PRODUCT CHANGE NOTICE

PCN#21-008

RC-4SPDT-A18
RC-8SPDT-A18

Upgrade of mechanical switch design

- Minor Changes to Switch Positions:

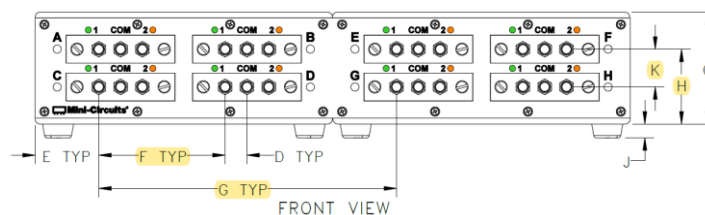
Model	Attribute	Before	After
RC-4SPDT-A18	Dimension F	1.47" (37.3)	1.50" (38.2)
RC-4SPDT-A18	Dimension H	.688" (17.48)	.757" (19.23)
RC-8SPDT-A18	Dimension F	2.57" (65.3)	2.55" (64.8)
RC-8SPDT-A18	Dimension G	6.00" (152.40)	6.01" (152.65)
RC-8SPDT-A18	Dimension H	1.47" (37.3)	1.50" (38.2)
RC-8SPDT-A18	Dimension K	.688" (17.48)	.757" (19.23)
